Groundwater Monitoring Plan Addendum,
Operable Unit 2, Northrop Grumman Systems Corporation and Naval Weapons
Industrial Reserve Plant (NWIRP) Sites, Bethpage, New York.
(NYSDEC Site #s 1-30-003A and B)

**LOCATION OF ON-SITE GROUNDWATER
 REMEDY AND WELLS**

FIGURE
1

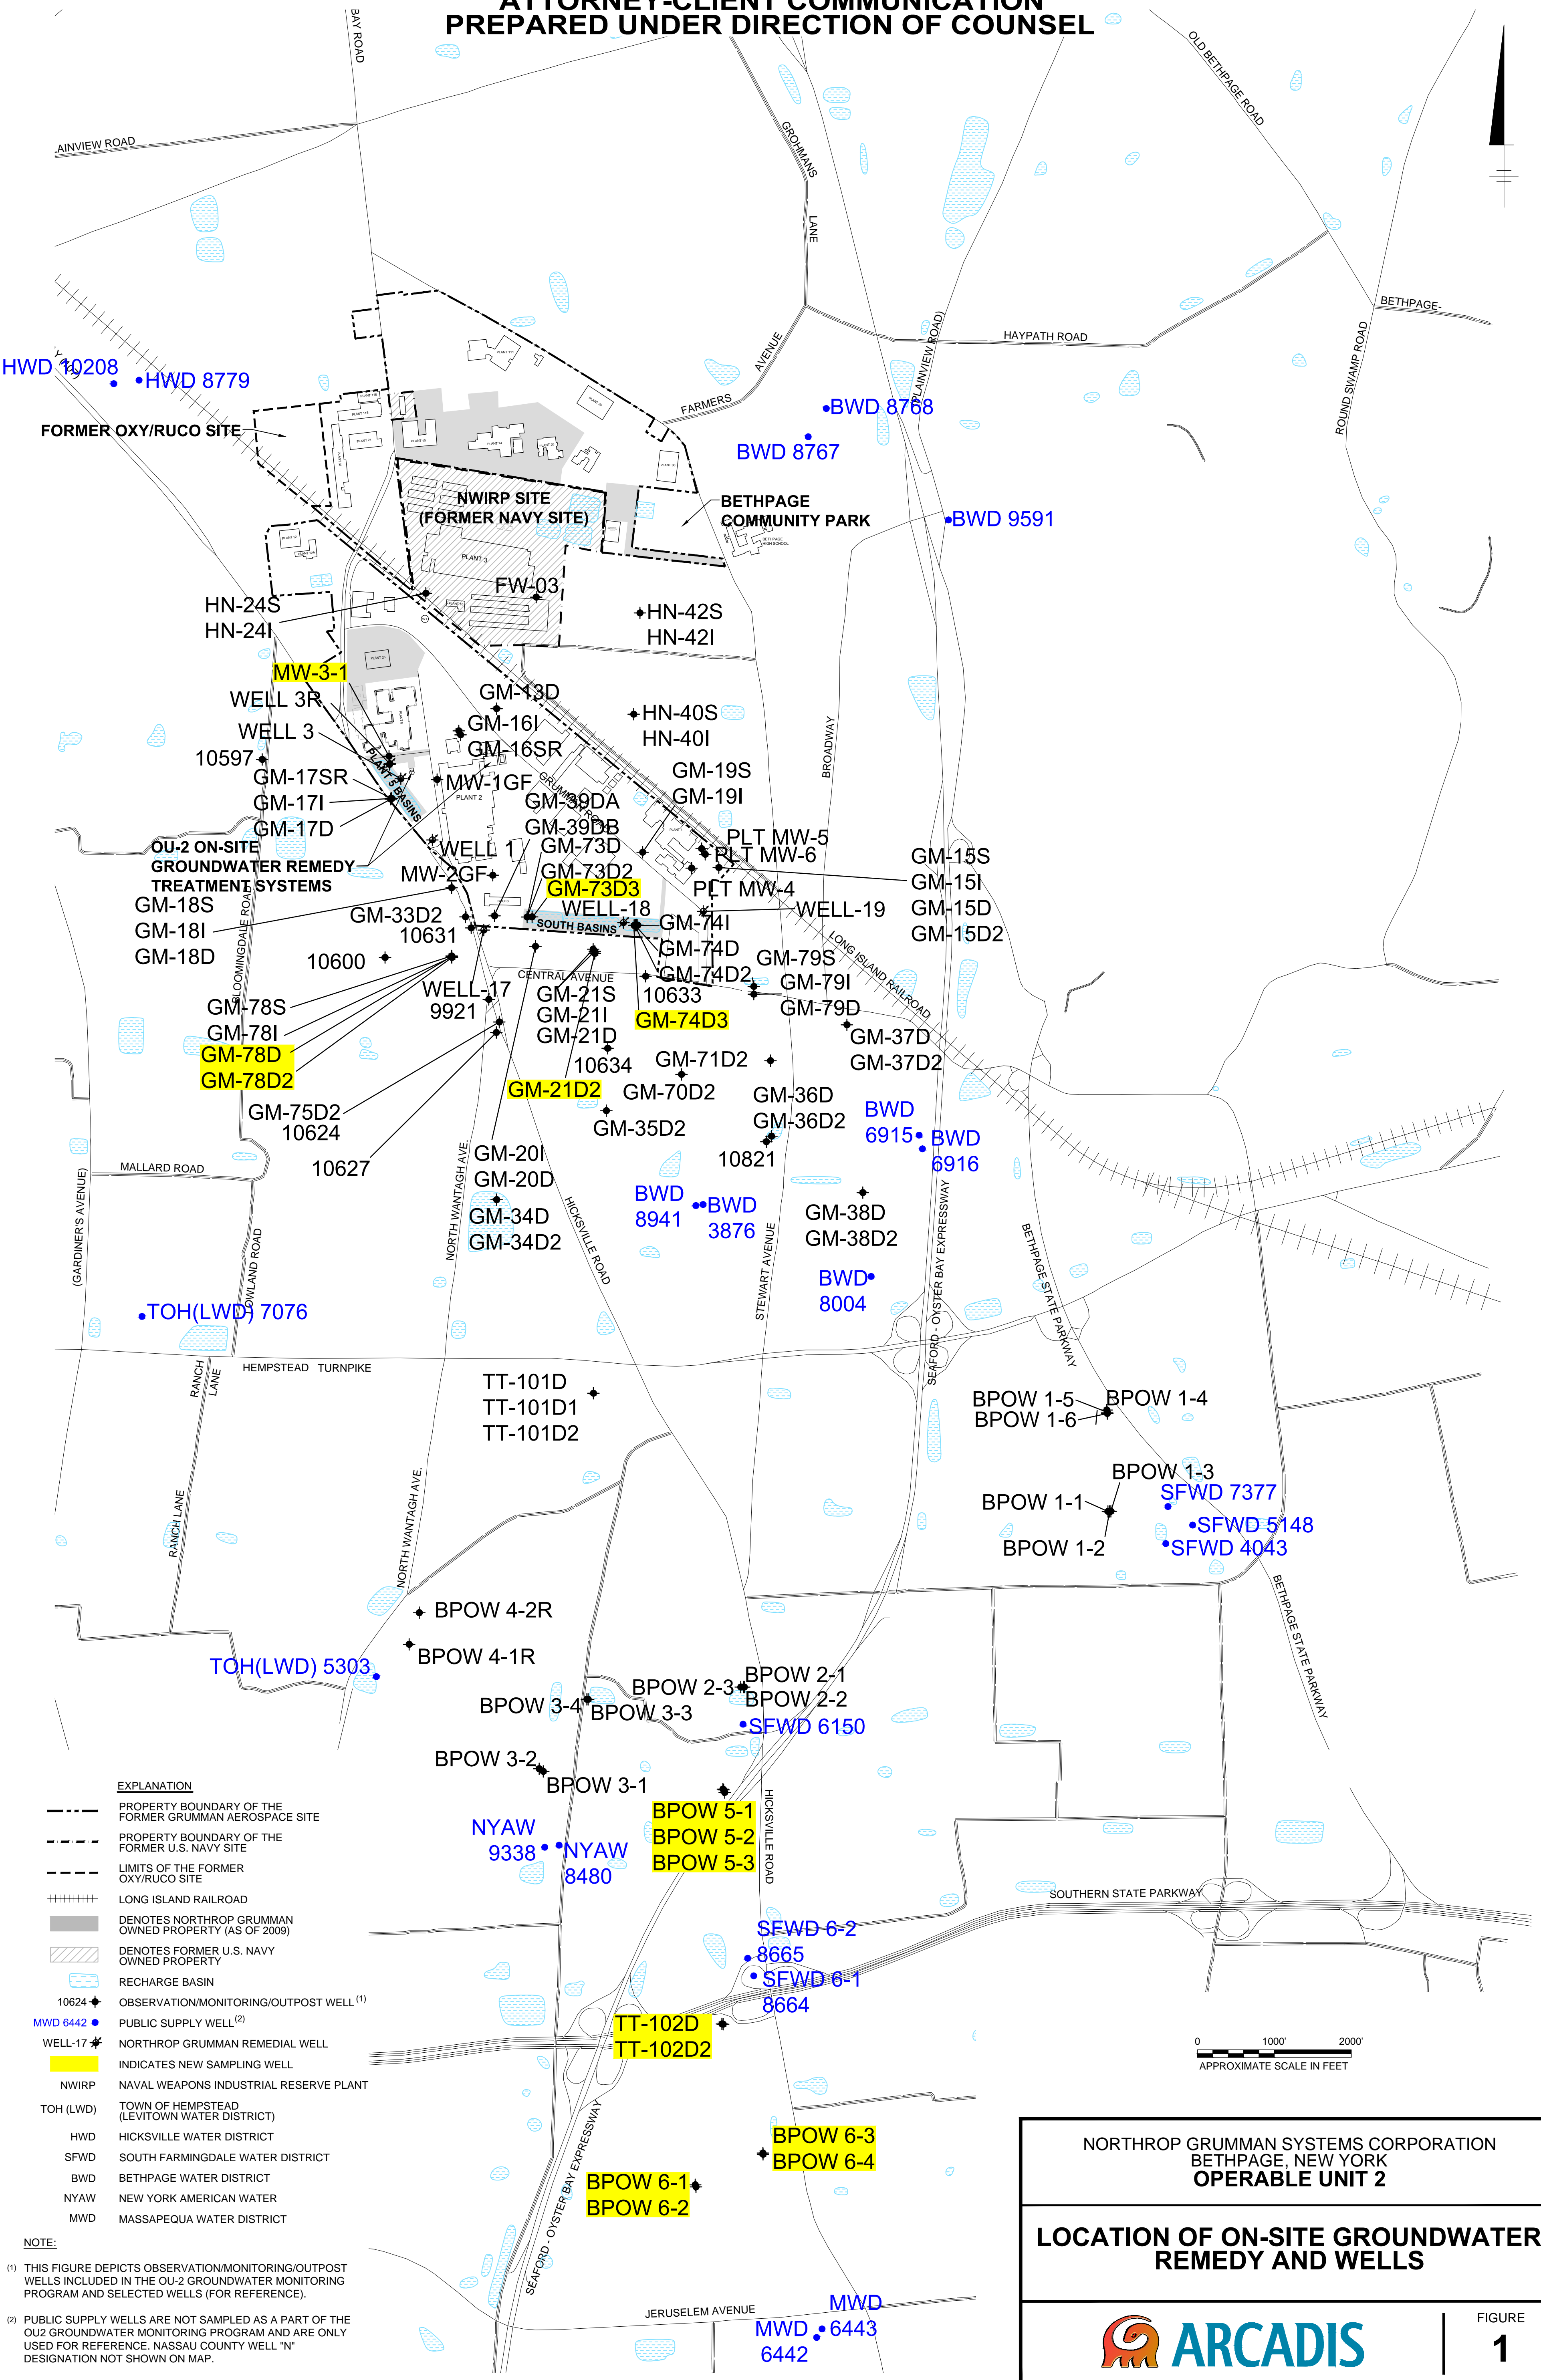
On behalf of Northrop Grumman Systems Corporation (Northrop Grumman), ARCADIS is submitting the enclosed proposed Addendum to the Groundwater Monitoring Plan in accordance with the Administrative Order on Consent for Operable Unit 2 (OU2 Consent Order, effective on May 1, 2015). Northrop Grumman previously submitted a Groundwater Monitoring Plan to NYSDEC in May 2014 (ARCADIS, May 2014) as part of the ONCT OM&M Plan (i.e., Appendix A). NYSDEC has accepted the existing OM&M plan as satisfying one of the deliverable requirements under the OU2 Consent Order, as confirmed in Dan Riesel's May 6, 2015 email to NYSDEC. We are requesting NYSDEC approval of this proposed addendum, consisting of enclosed Tables A1, A2, A3, and Figure 1, which updates the Groundwater Monitoring Plan previously submitted to NYSDEC (Note: updates are highlighted in the enclosed tables and figure):

- Supplements the OU2 groundwater monitoring program by adding six monitoring wells (Monitoring Wells MW 3-1, GM-21D2, GM-78D, GM-78D2, GM73D3, and GM-74D3) to the semiannual hydraulic and groundwater quality monitoring rounds. These changes were previously recommended in the 2013 Period Review Report (ARCADIS, October 2014), 2014 Annual Report (ARCADIS, March, 2015), and incorporated into the most recently submitted Groundwater Monitoring Plan (ARCADIS, May 2014; Appendix A of the OM&M Manual).
- Changes the sampling frequency from quarterly to semiannually for the original nine outpost wells (Public Water Supply Contingency Plan [PWSCP],

- In cooperation with the Navy, adds seven new outpost wells (associated with BPOW 5 cluster and BPOW 6 cluster) to the program at a quarterly monitoring frequency (standard for outpost wells) and adds two new plume monitoring wells (TT-102D and TT-102D2) to the program at a semi-annual monitoring frequency. These wells were installed by Navy and will be sampled by ARCADIS following the Navy's protocols that were approved by the NYSDEC (UFP SAP Addendum Ground Water Sampling Using Low Stress [Low Flow] Purging and Sampling Protocol, Resolution Consultants, November 2013). The Navy will complete the reporting requirements and data distribution associated with these wells.
